Agreement No. CE 36/94
Reclamation and Servicing of
Tuen Mun Area 38 for Special
Industries - Improvement to
Roads and Junctions within Tuen
Mun Environmental Impact
Assessment :
*Environmental Impact Assessment
Report*

Agreement No. CE 36/94
Reclamation and Servicing of Tuen Mun Area 38 for Special Industries -
Improvement to Roads and Junctions within Tuen Mun
Environmental Impact Assessment Report
Final Report

ADDENDUM

FIGURE 5.6b - NOISE ENCLOSURE ARRANGEMENT - WONG CHU ROAD

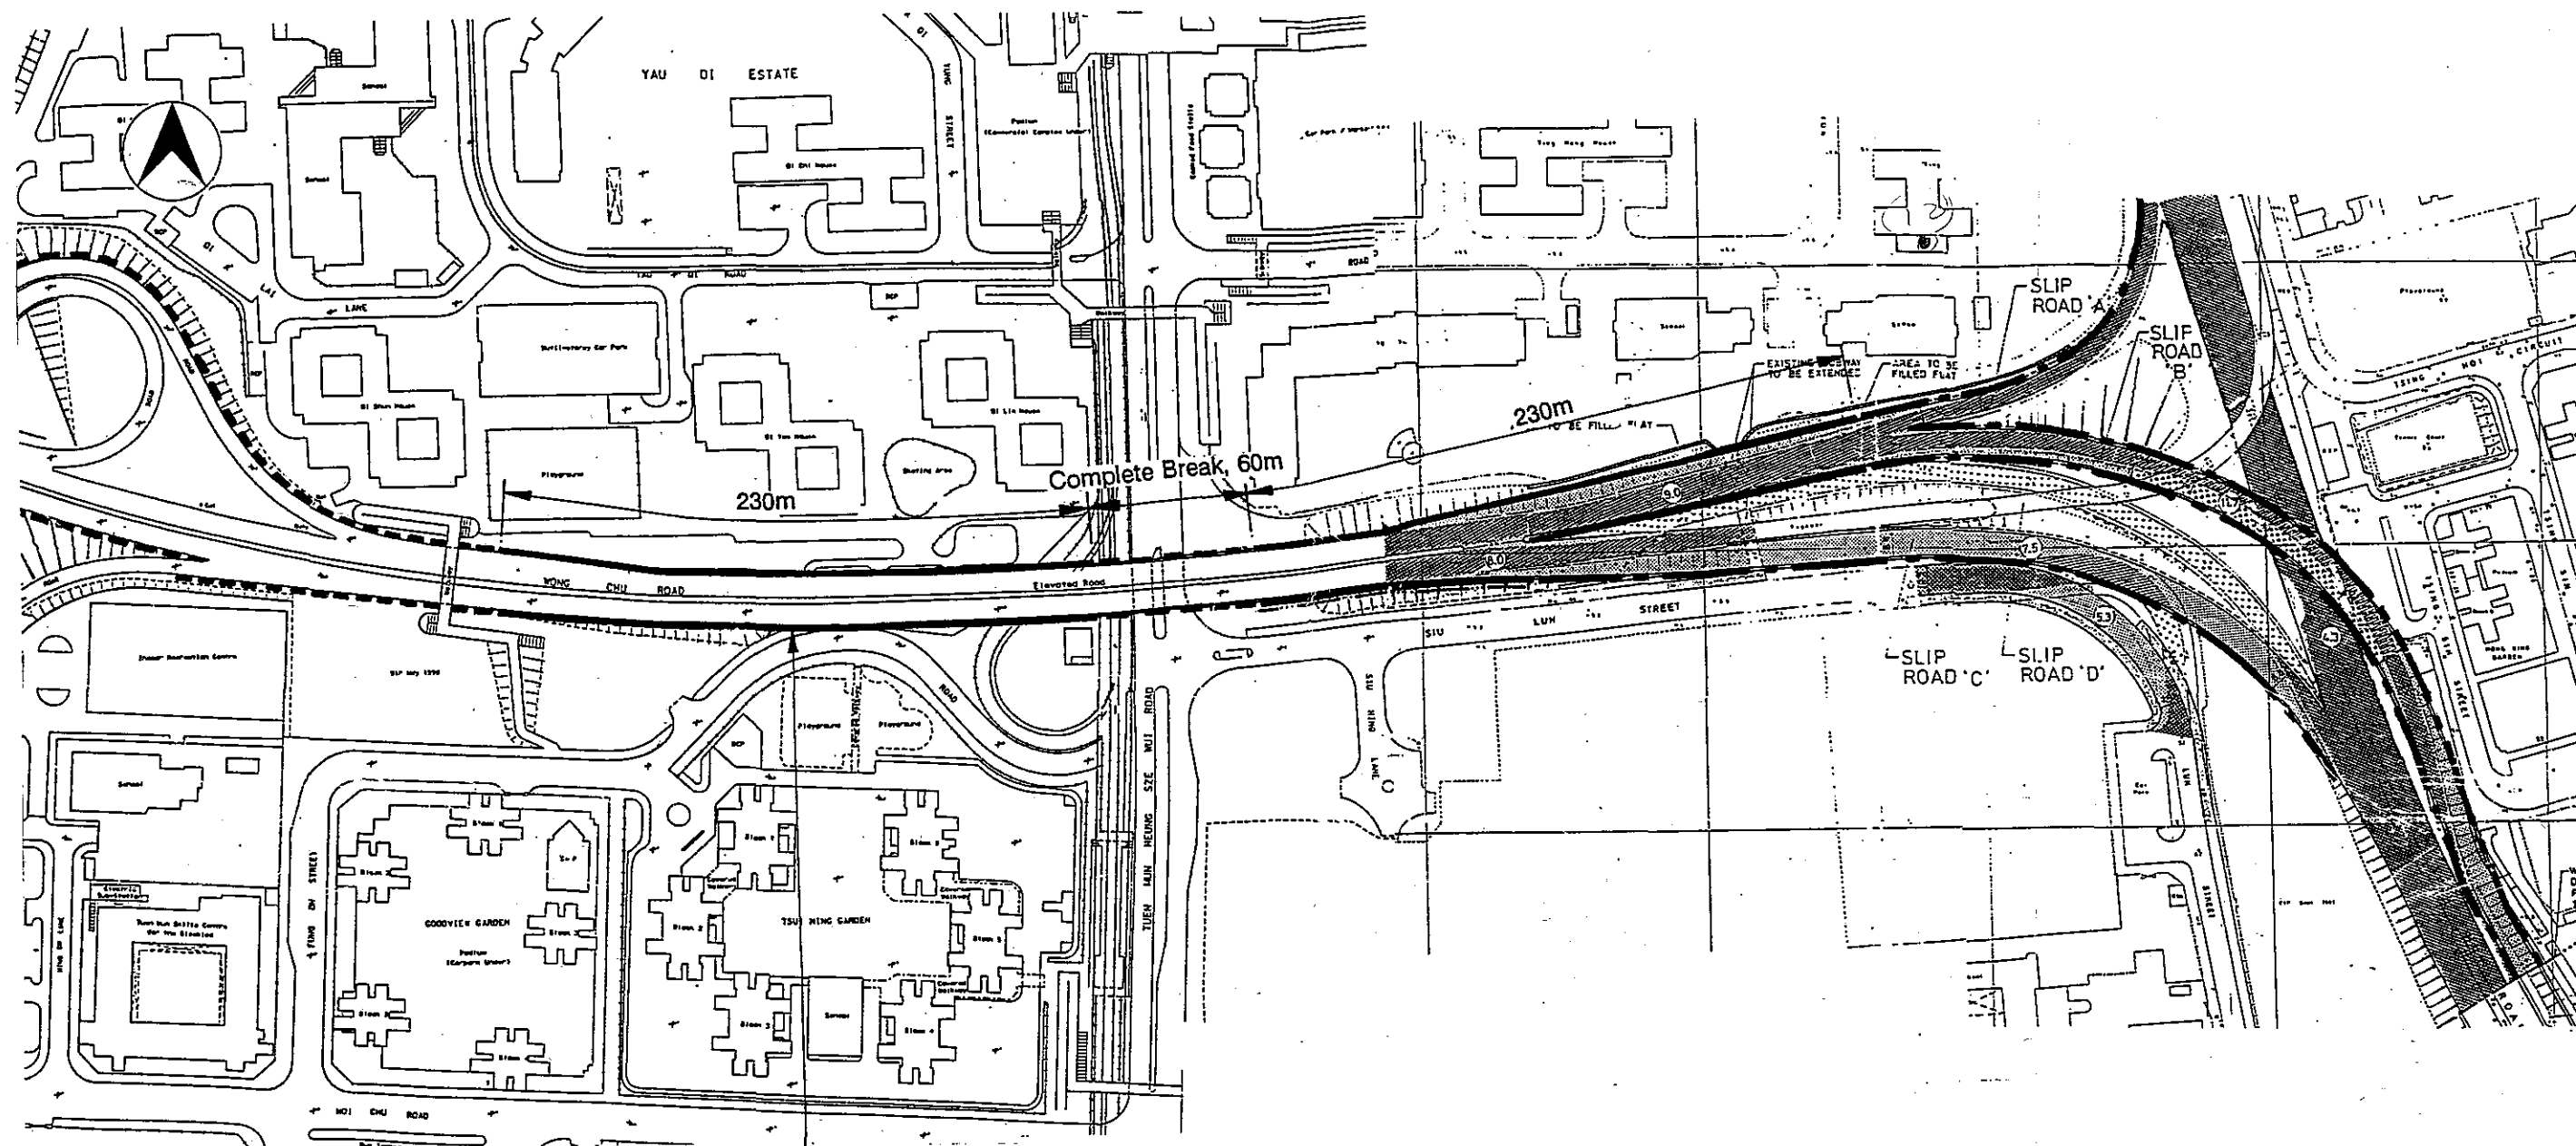
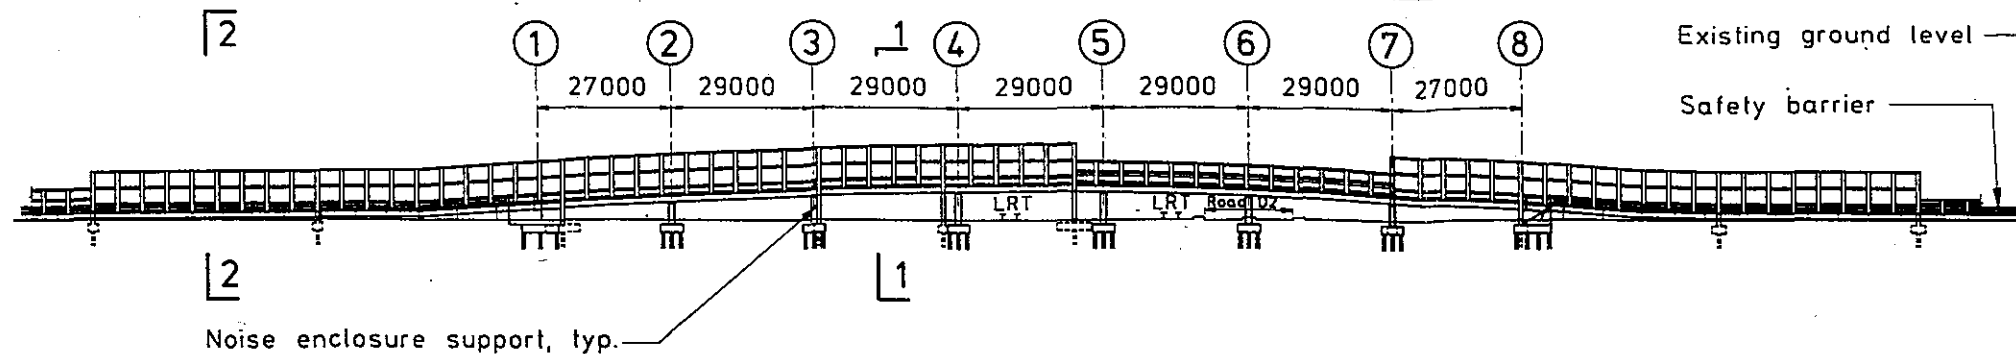
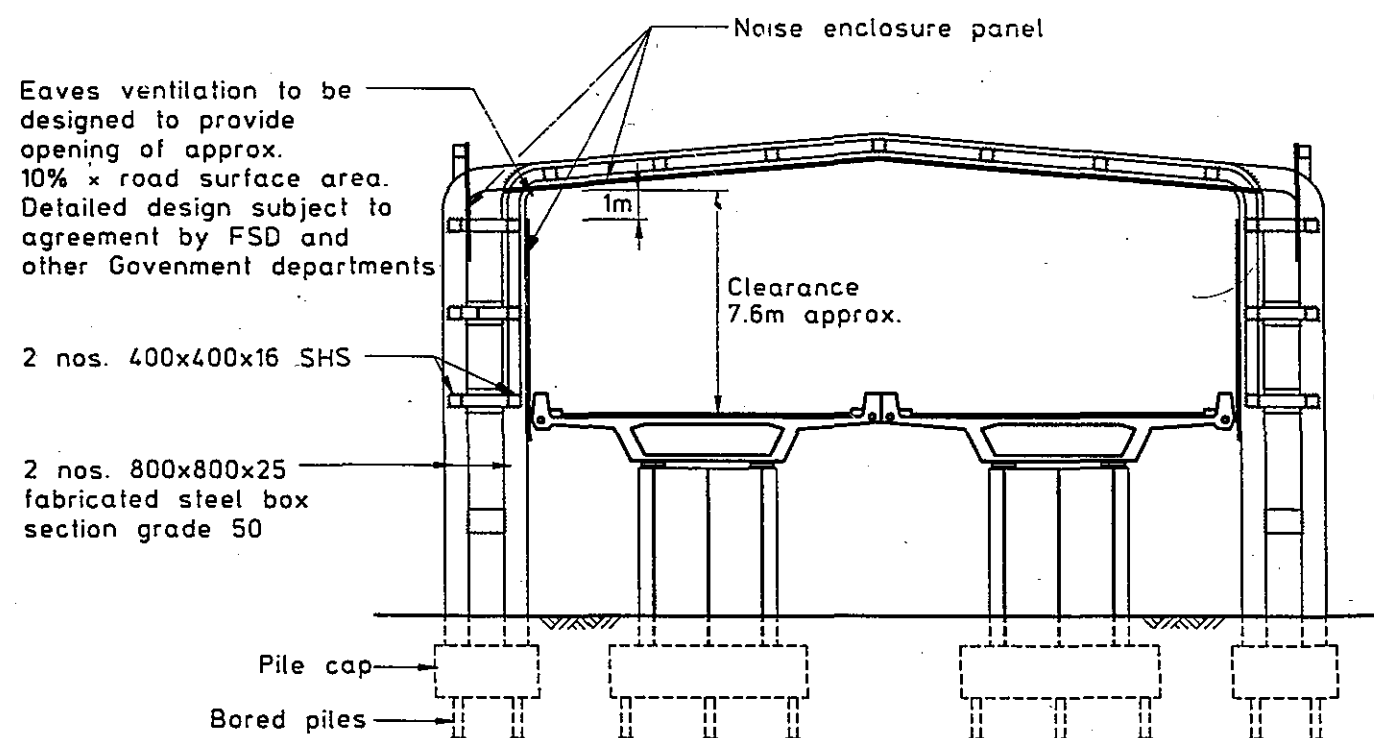
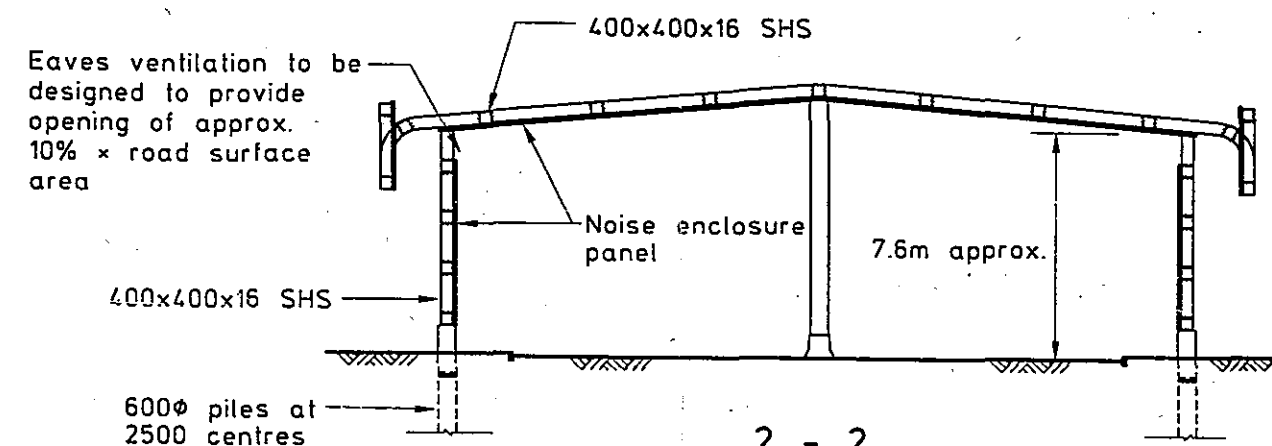
24			<p>(d) Proposed enclosure design (Fig 5.6b)</p> <p>The arrangement of putting the footway between the enclosure wall and the existing boundary wall is entirely unacceptable. Please note that the human scale will be totally lost with such arrangement. In particular, the "enclosed corridor" will become a crime spot. At this stage I would suggest:</p> <p>i. negotiation should be made with other relevant parties to replace the existing boundary wall with appropriate landscape measures;</p>	<p>Noted.</p> <p>Agreed. Typical sections only are given in Figure 5.6b. For the actual locations finally proposed for noise enclosure (Option 4), there is no footway alongside the road carriageways and so no "crime spot" problem would exist. Figure 5.6b will be revised to clarify this.</p>
25			<p>ii. footing of the enclosure structure should be designed to avoid intrusion into the footway area so that the chance of providing appropriate landscape measures along the future footway will not be exploited.</p>	Agreed. Similar response to comment (i) above, there will be no footways alongside the road. Figure to be revised.

No.	Department	Reference	Comments	Consultants' Response
47			<p><i>Figure 5.6 a & b</i></p> <p>Please indicate clearly how barriers/covers can be built over Wong Chu Road (both bridge section and embankment section) and Tuen Mun Road. As the Wong Chu Road and Tuen Mun Road are existing roads, please be specific and avoid referring to standard details.</p>	Noted. The Consultants will include sketches specifically for these sections in the Final Report.
48			<p><i>5.7 and Annex C</i></p> <p>Please provide full details of construction and insulation costs breakdowns. Please advise the residual noise level at NSRs upon completion of the insulation works. Please also advise which party will be responsible for paying the electricity charges in case A/C units are provided.</p>	Noted and agreed. Full details of cost breakdowns will be provided in the Final Report. However insulation is no longer required according to the revised noise modelling assumptions agreed with EPD.
